Milldale Primary School NoR - s92 Transport Response

Prepared for: Ministry of Education
Job Number: MED-J015
Issue Date: 19 March 2020
Prepared by: Shane Ingley, Senior Transportation Engineer
Reviewed by: Jo Draper, Associate Transportation Planner

Figure 2.1 Intersections tested in this memo and in the ITA

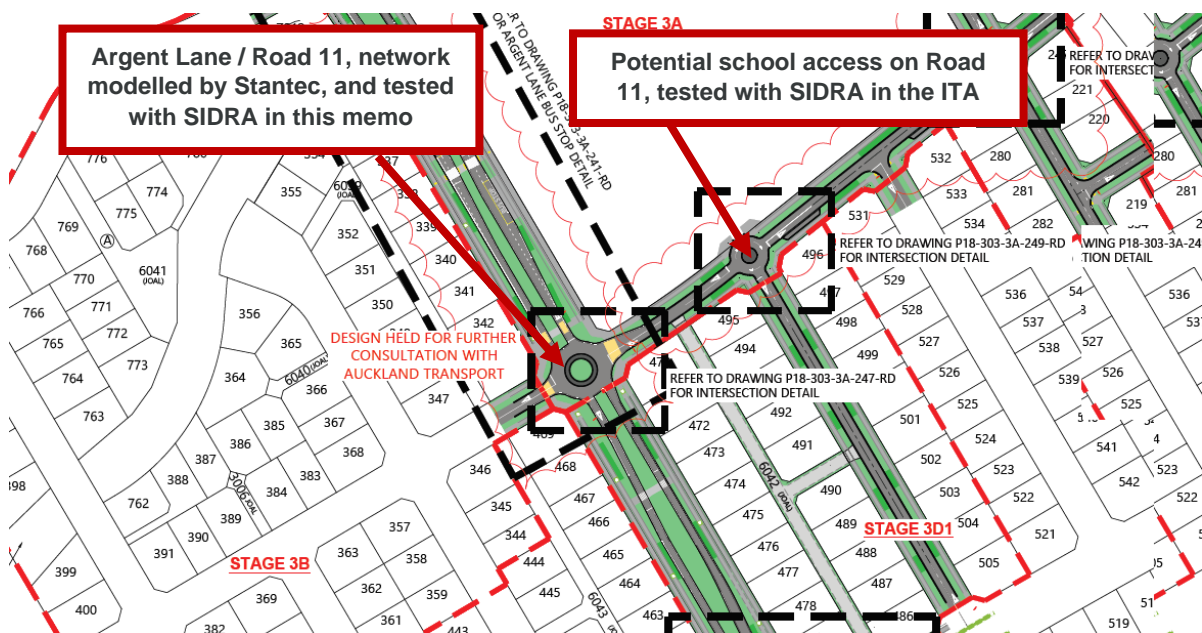
- The intersection of Argent Lane / Road 11 has been assessed using a network modelling package. Whilst this provides a high-level assessment of the operation of the intersection, network models are not typically appropriate for examining the operation of intersections in detail. To fully understand the operation of the intersection, an intersection modelling package, such as SIDRA, should be used and results provided together with detailed output such as degree of saturation, delays and queue lengths.*

We have assessed the Argent Lane / Road 11 intersection using SIDRA. It has been tested as a roundabout using the approximate dimensions shown in Fulton Hogan’s layout plans. The SIDRA outputs are attached at the end of this technical note. The location of the intersection and the testing undertaken are indicated in **Figure 2.1**.

We tested the full buildout scenario as this is the most conservative – this scenario, as described in Stantec’s Technical Note, accounts for a full housing population in Milldale as well as a full school roll at the proposed school location (ie. the overall heaviest traffic volumes anticipated in the precinct based on planned development). SIDRA testing shows that the roundabout is estimated to perform at overall LOS A, with some movements at LOS B. This is based upon the traffic volumes as used in Stantec’s technical note.

As a further sensitivity test and to align with SIDRA modelling at the school entrance, we have considered that local effects of school traffic may be more concentrated on Road 11 than the volumes indicated in the network model. Therefore, we have also tested a set of traffic volumes scaled up on the Road 11 (eastern) approach to Argent Lane, such that they more closely match Abley’s trip generation estimated in the ITA, which is more conservative than the network model. This results in an intersection LOS of B for the morning peak, and LOS C for the afternoon peak. The critical movements are in the afternoon peak on the southern approach to the intersection (Argent Lane), where the high volume of through movements results in queuing (LOS D). LOS D is a relatively normal situation for busy urban roads, such as Argent Lane is anticipated to be.

Therefore, the level of congestion likely to occur at full buildout of the precinct (and with a full school roll) does not necessitate the intersection being signalised.

Figure 2.1 Tour coach vehicle tracking

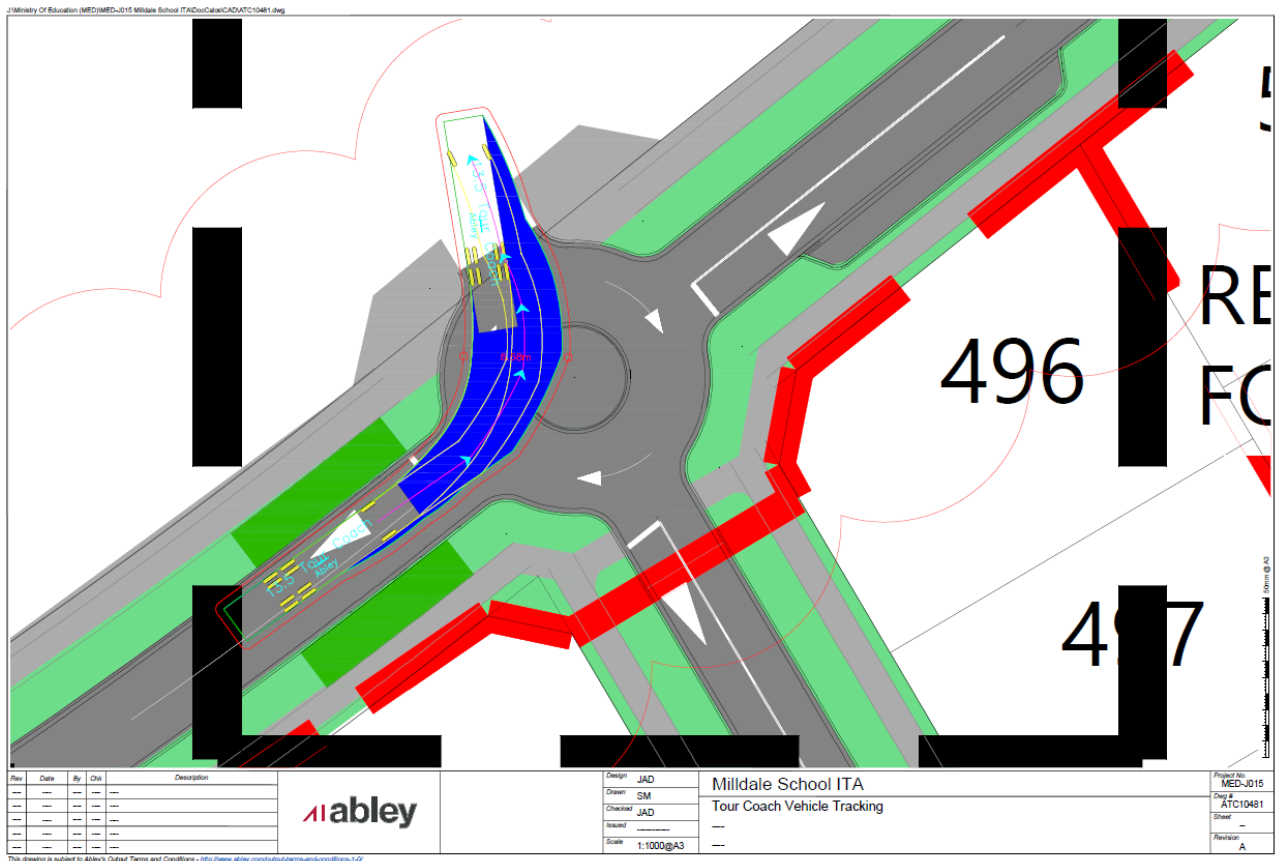
- 6) *Students to the primary school are not anticipated to travel by public transport to the school. However, from time to time, coaches may be required to attend the school to take pupils on school trips. Details of how coaches will be able to access the site and the local roads should be provided.*

While the actual design of a vehicle access will be undertaken in detail at the OPW stage, we have considered that on occasion vehicles larger than a car may need to access the site - **Figure 2.1** shows that a coach is able to access the site via a mountable mini roundabout as currently proposed at this intersection (School Access / Road 11 intersection); the vehicle tracking indicates that some design work will be necessary on the accessway at the OPW stage in order to accommodate the entry path; the actual design will depend upon other outcomes such as whether a two-way or one-way access at this point is proposed. Any proposed design will be subject to an assessment of practicality of entry and egress for a coach (ie. if a separate exit point is proposed, it will be designed to accommodate a coach exiting).
